19 December 2025

Buller District Council
PO Box 21
WESTPORT 7866

JOHN RAYMOND MCLAUGHLIN – RC250005 REQUEST FOR FURTHER INFORMATION UNDER S92

Blk 11 Waitakere SD

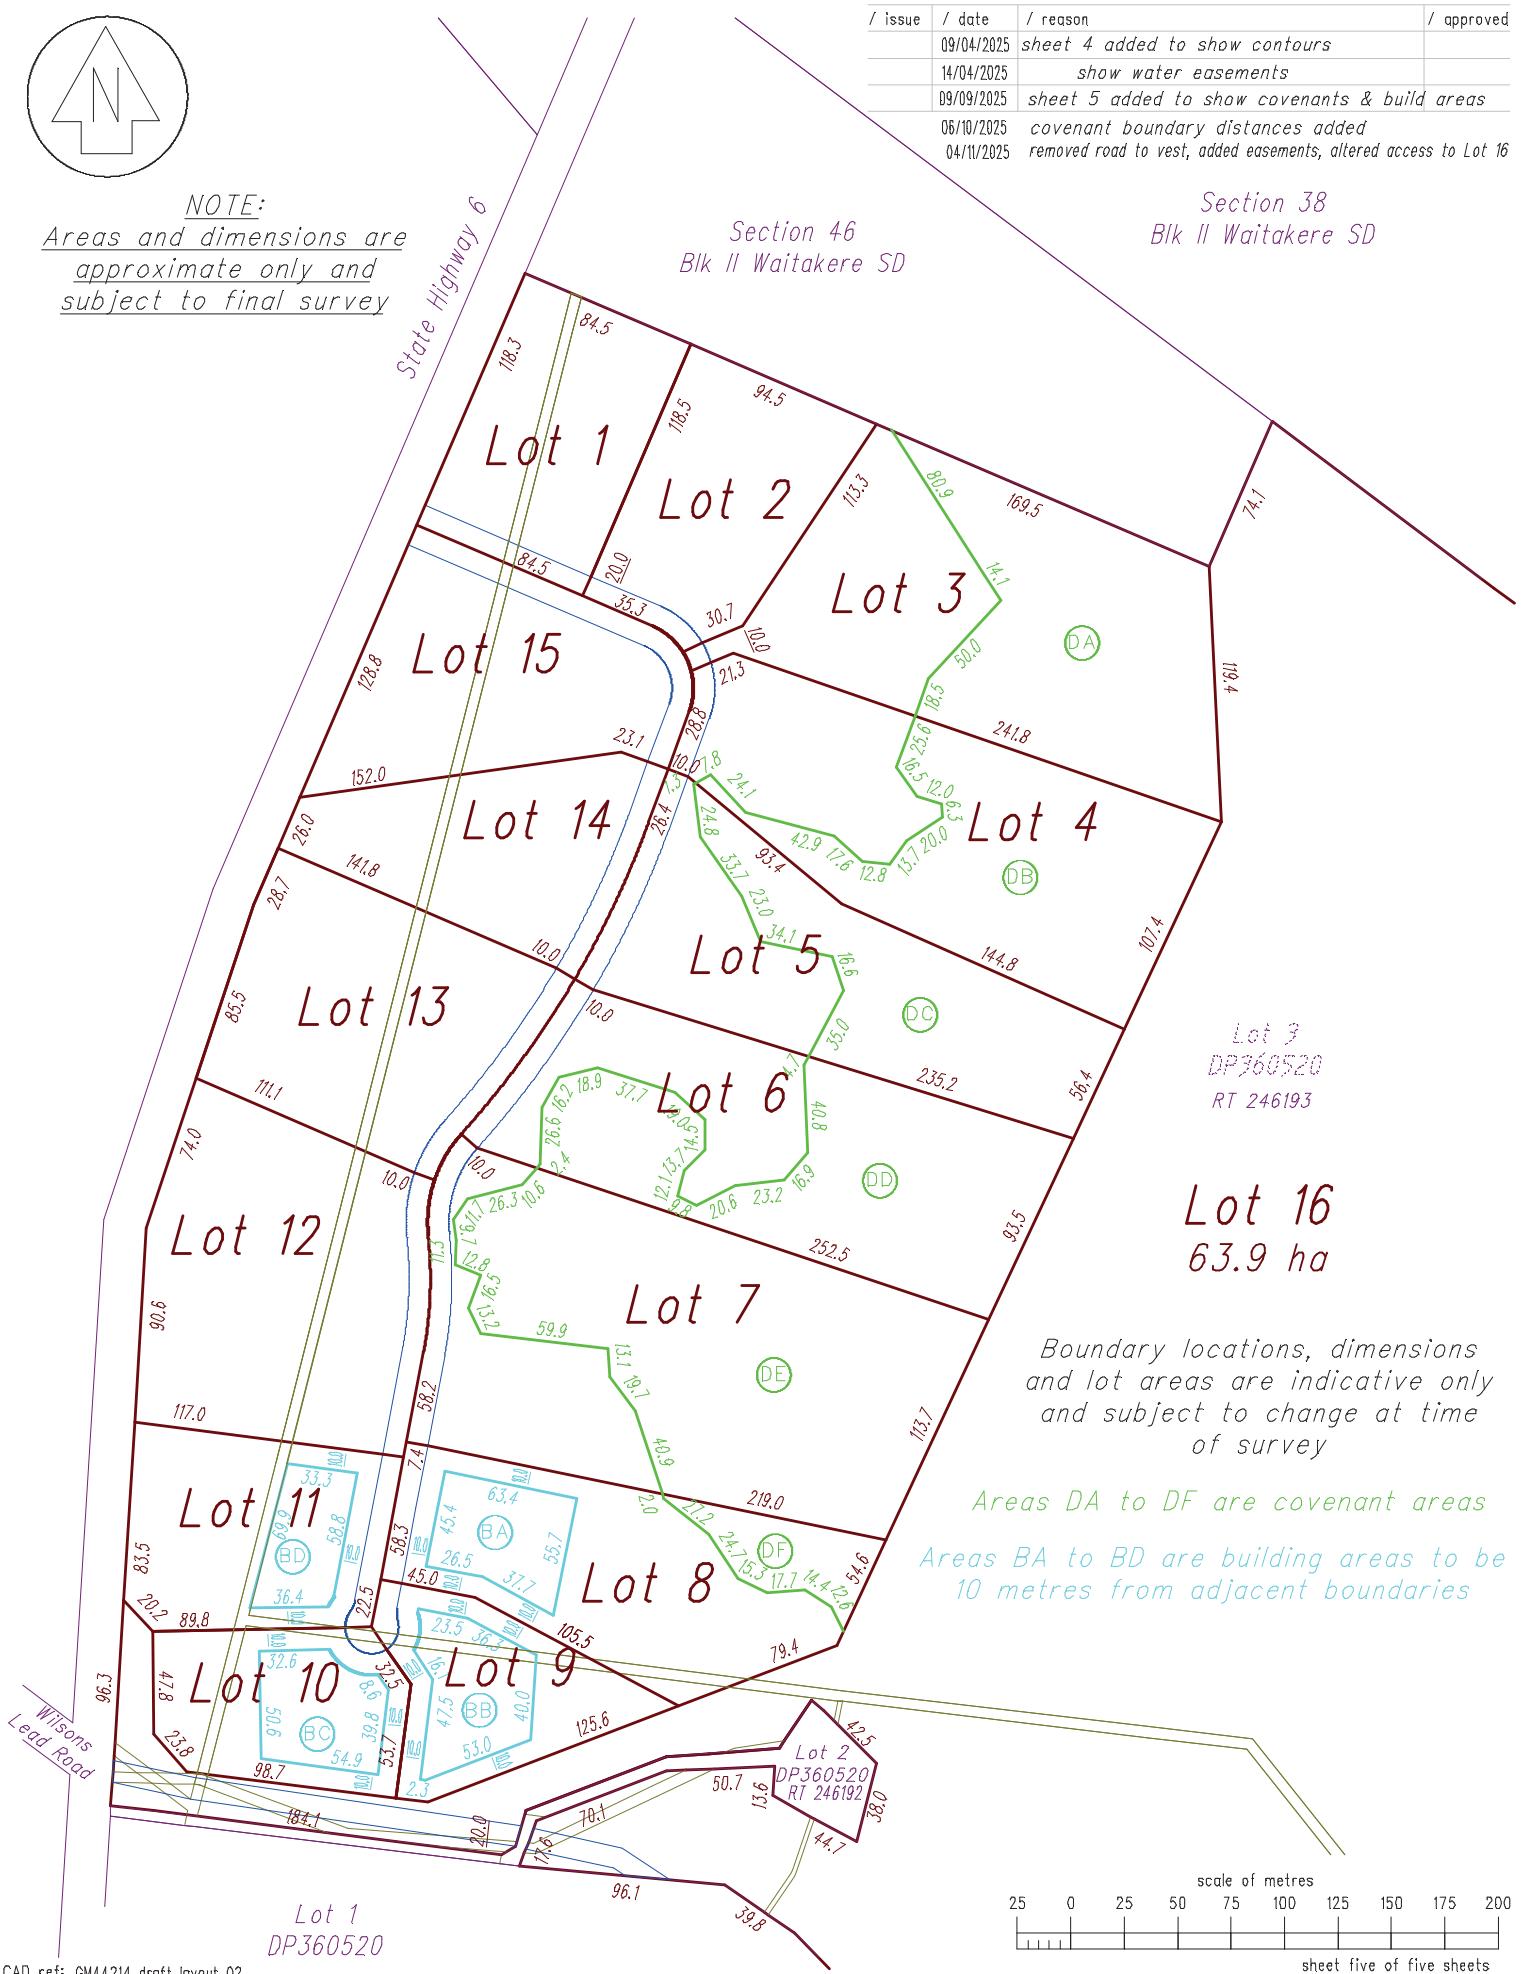
As per email correspondence with Sarie van der Walt of Buller District Council (correspondence attached as **Appendix A**), Sarie has made it very clear that Buller District Council will not be accepting Lot 18 as a vested road. As a result, the applicant has chosen to proceed with Lots 1 to 15 being accessed via a right of way, in favour of the 15 allotments.

Please note the minor change to the south-eastern boundaries of Lots 8 and 9 and access to the balance land is discussed under the heading "Access to Lot 17- 8 October 2025" below.

Section 3.1.2 of the application explains that easement R is required to provide access over Lot 2 DP 360520 to enable access to proposed Lot 17 and Lots 4 and 5 DP 360520. If easement R is not provided for, then the applicant will not have access to proposed Lot 17 of the subdivision. It was an omission that Lot 2 DP 360520 did not form part of the subdivision consent application. The owner of Lot 2 360520 is a family member. Affected party approval is in the process of being obtained and will be provided once received.

An updated Scheme Plan showing Lot 18 being replaced with the right of way is attached to this response as **Appendix B**. Also attached as **Appendix C** is an updated proposed easement schedule.

As a result of the creation of the right of way, the boundaries of Lots 1 to 15 have been amended to include the easements necessary for the right of way. This has resulted in minor changes to the size of Lots 1 to 15, that will not impact on the ability to undertake building development on each allotment. The change in area of each allotment considered to have less than minor effects on the environment as they are for the purpose of providing access to each allotment. Therefore, these changes are considered to be positive and achieves the relevant objectives and policies within the Buller District Plan.

An updated Scheme Plan is attached to this response. The Scheme Plan shows the boundaries of Lots 8 and 9 have been amended to enable access to the balance land to be to the northwest of Lot 2 DP 360520. On previous versions of the Scheme Plan, the balance land was identified as Lot 17. As access to the balance land is not required over Lot 2 DP 360520, a separate allotment is not required for the

balance land. Therefore Lot 17 has been combined with the area previously identified as Lot 16 to create a new Lot 16 that is 63.9 hectares in area.

To be clear easement R is not required and Lot 16 will not have access from the newly proposed right of way.

This change results in lots 8 and 9 each being reduced in size by approximately 2000m². This change does not compromise the ability for building development to occur on Lots 8 or 9 in the future. Rule 7.4.2 of the Buller District Plan requires every owner or occupier of land to provide vehicular access to the site for parking and loading over the site by provision of a vehicle crossing constructed to the boundary of the site. The change to this scheme plan ensures the subdivision complies with Rule 7.4.2 as all allotments will be provided with vehicular access. Therefore, this change is considered to have less than minor effects on the environment, with these being positive, and it will achieve the relevant objectives and policies within the Buller District Plan. I trust this response address the email dated 8 October 2025.
